Innovative Urban Village

East New York
Christian Cultural Center (CCC)

220311 ZSK
220312 ZMK
220313 ZRK
220314 ZSK

CPC Review Session | Post Hearing

Flood Map

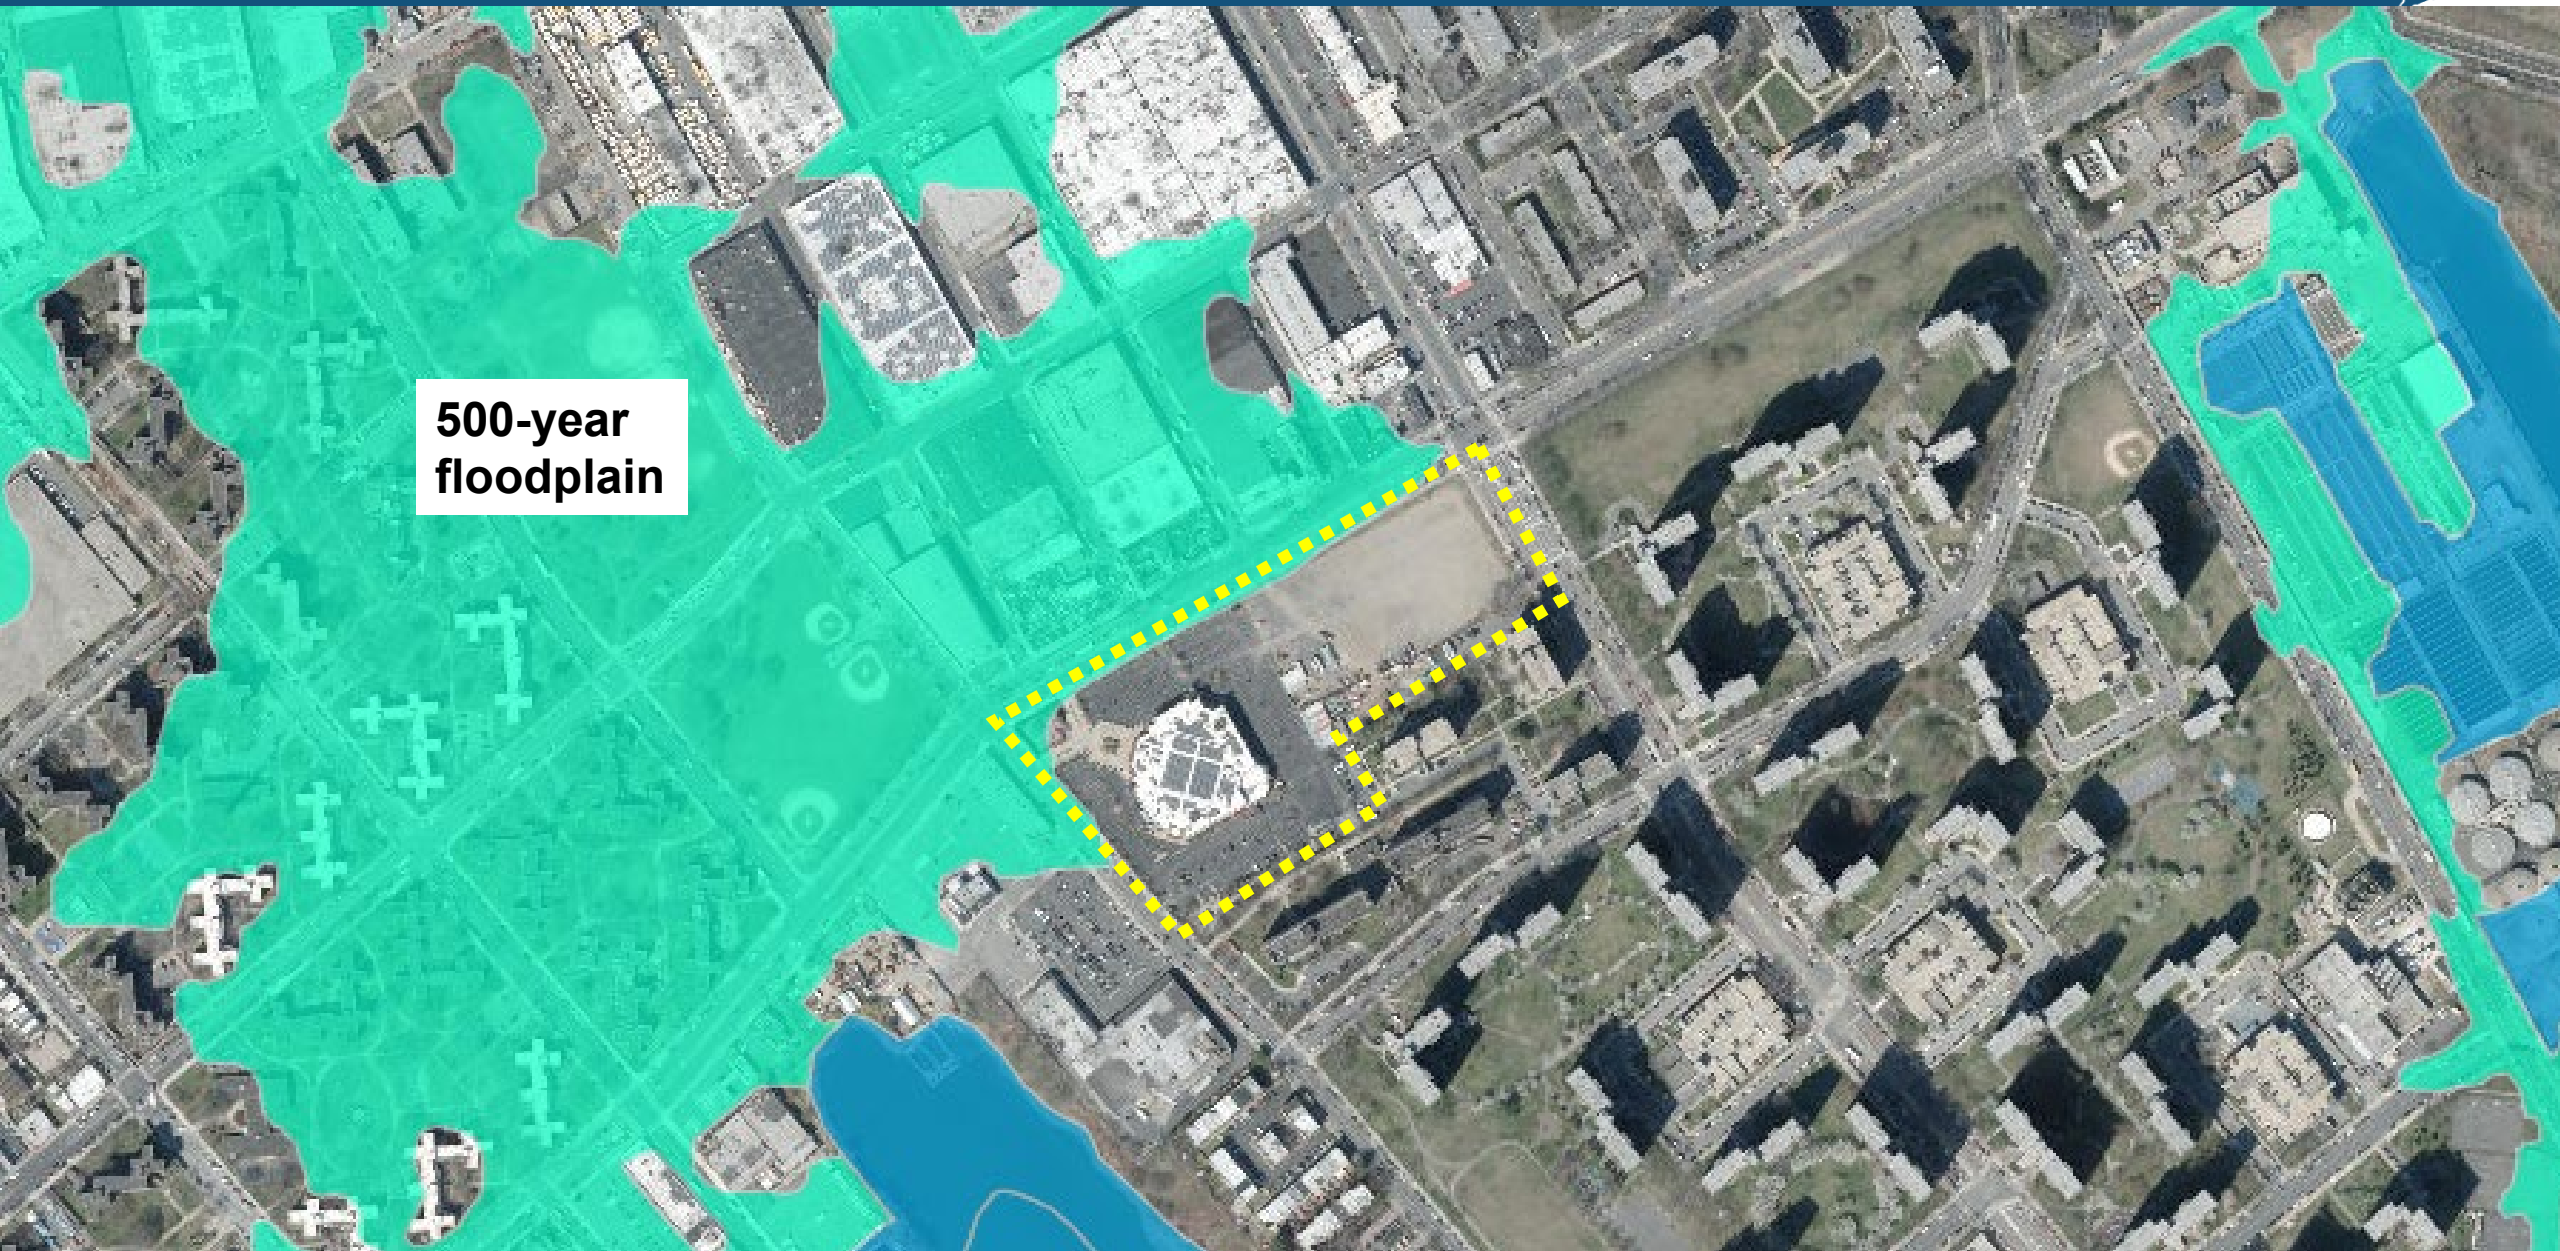
Resiliency issues raised at the public hearing:

- A portion of the site at Flatlands and Louisiana avenues is within the 500-year floodplain
- The proposed site plan is open at this intersection, potentially allowing flood waters into the site
- The removal of existing trees at this location might pose flood risk issues

Applicant response:

- The site will be elevated out of the 500-year floodplain through site grading
- The intersection will be planted with permeable materials to absorb water
- Building mechanicals will be elevated
- Residential entries and ground floor uses will be elevated
- The proposed open space plan will increase porous space from 29,000 to 46,000 sf
- Number of trees will increase from 125 to 150 and existing street trees will generally remain

Original Building Heights

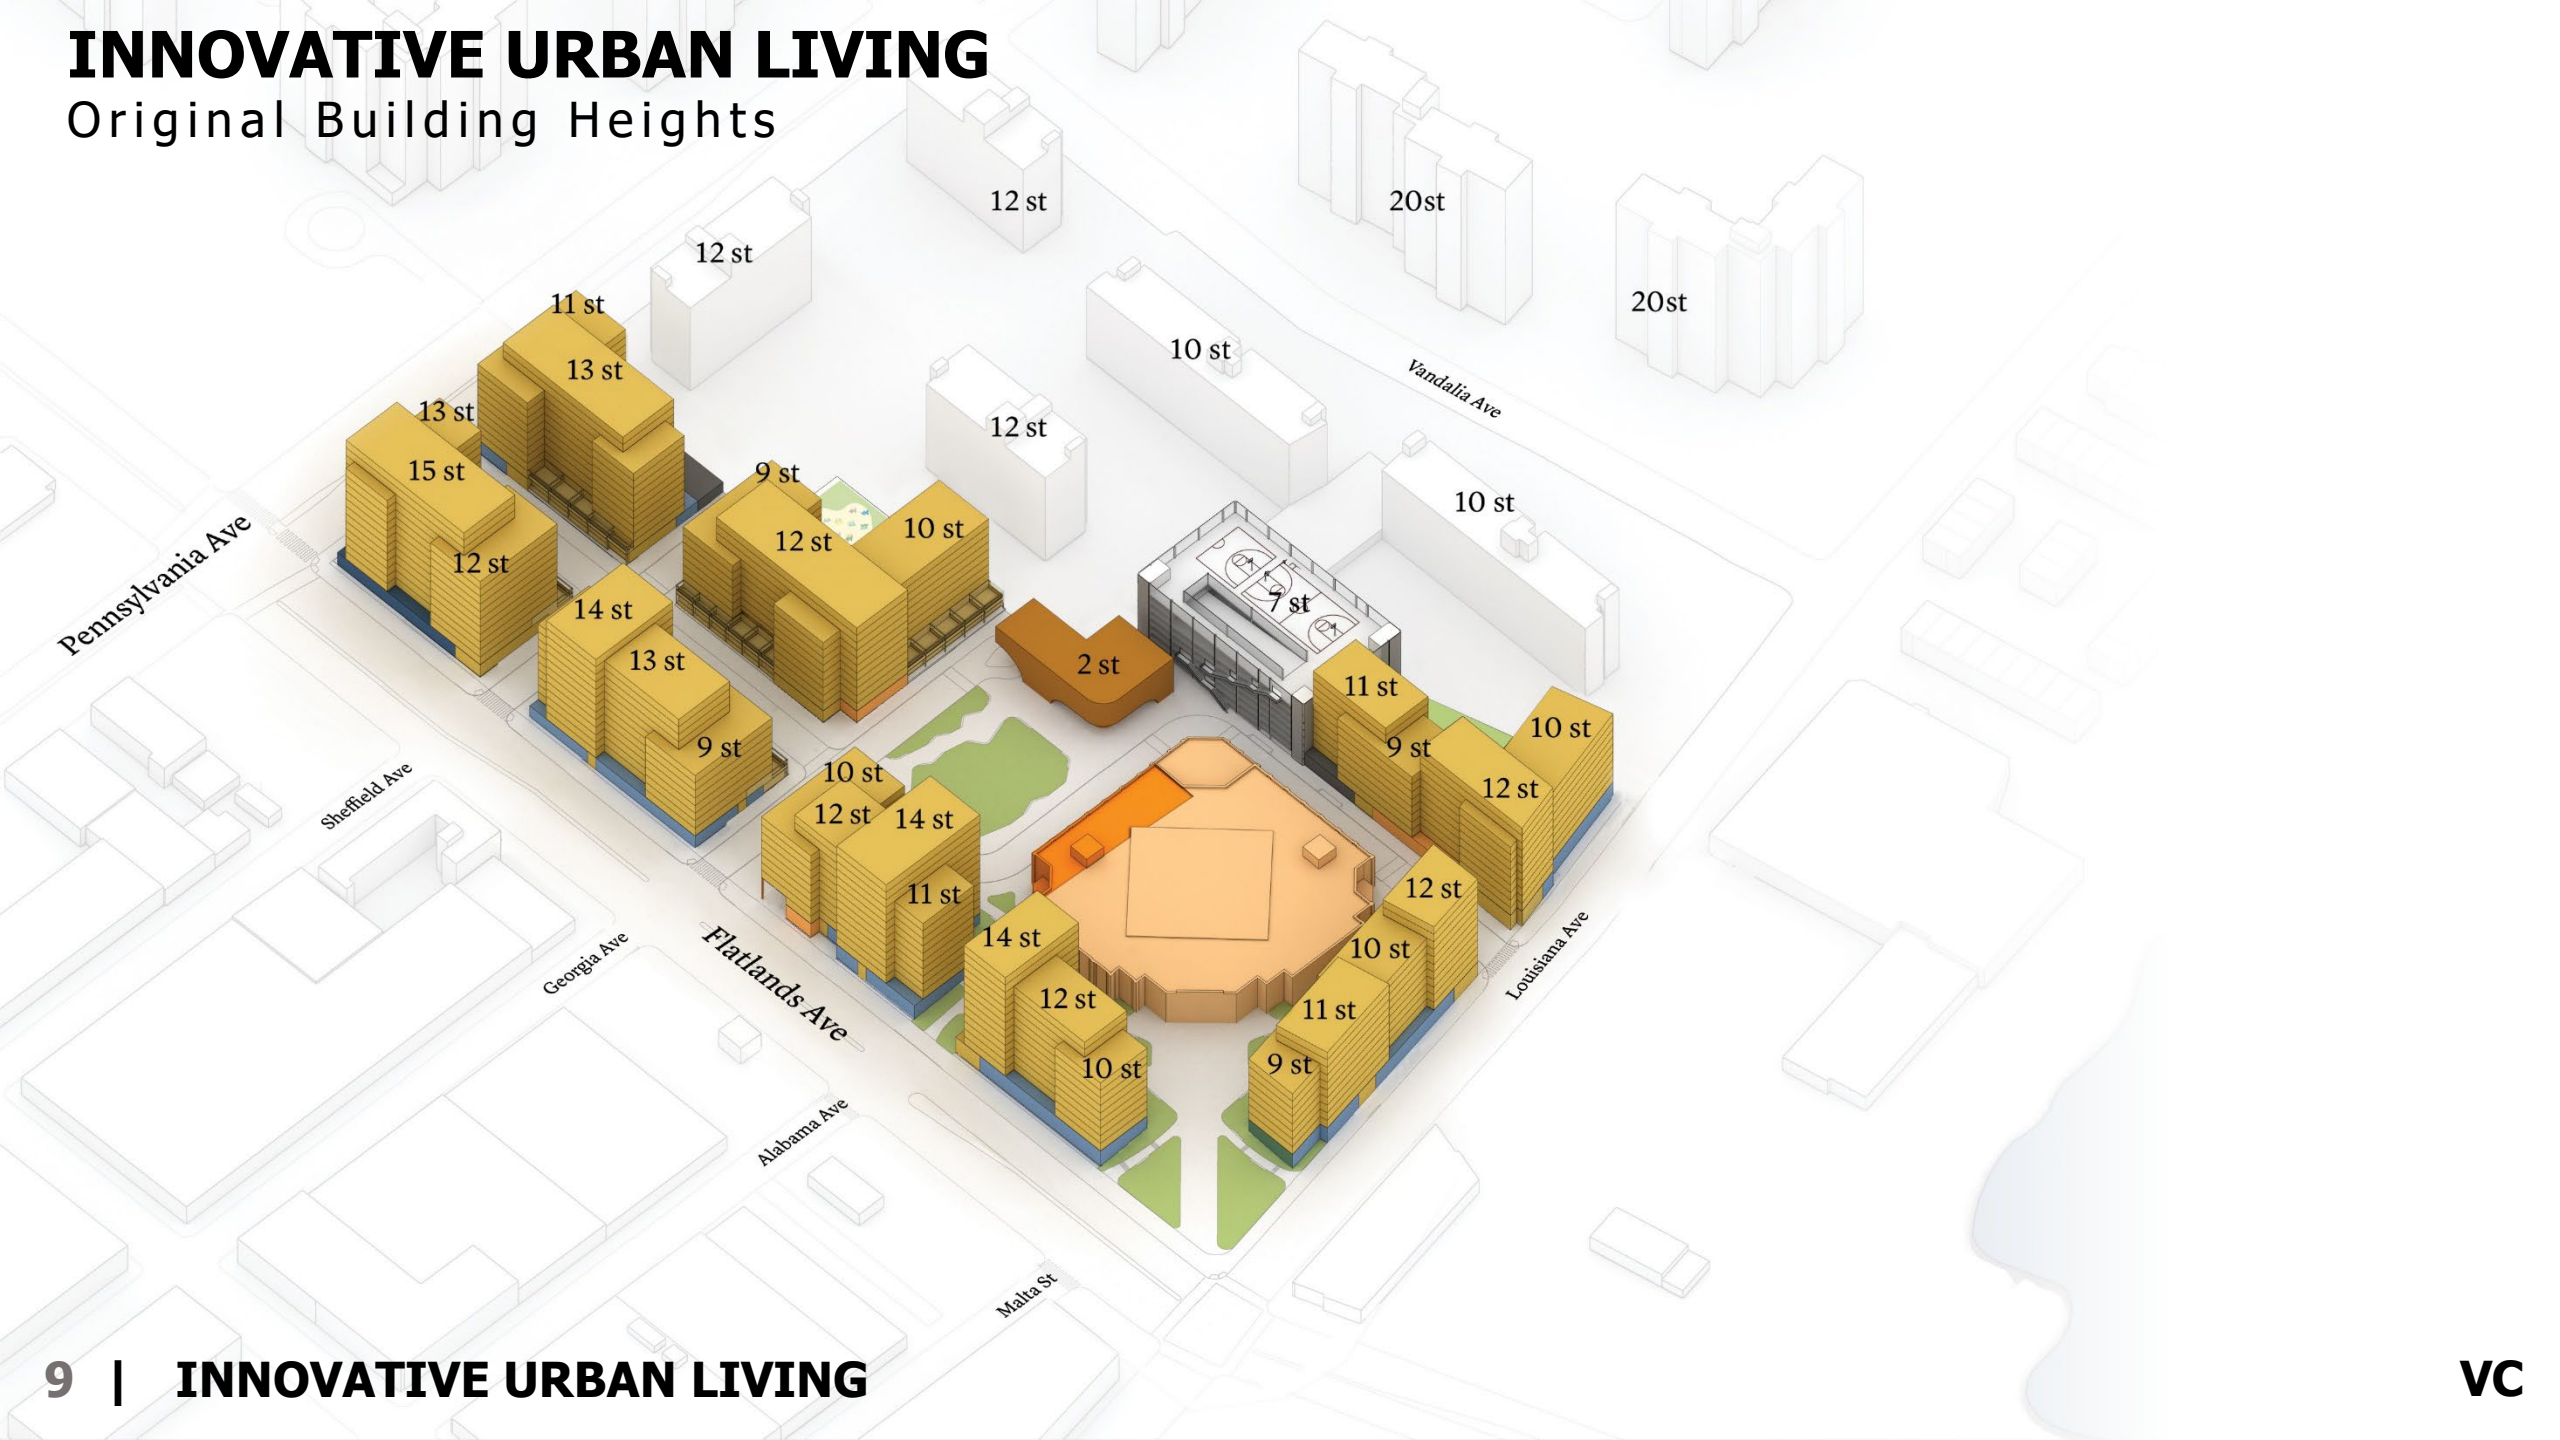
The applicant is seeking to modify the certified drawings as follows:

- Reduce the number of stories of four buildings along Flatlands Avenue:
 - Building 1: 15 to 14
 - Building 4: 13-14 to 12-13
 - Building 5: 14 to 13
 - Building 6: 14 to 13
- Design notes to accommodate construction of maisonettes
- Updated details/refinements to open space design
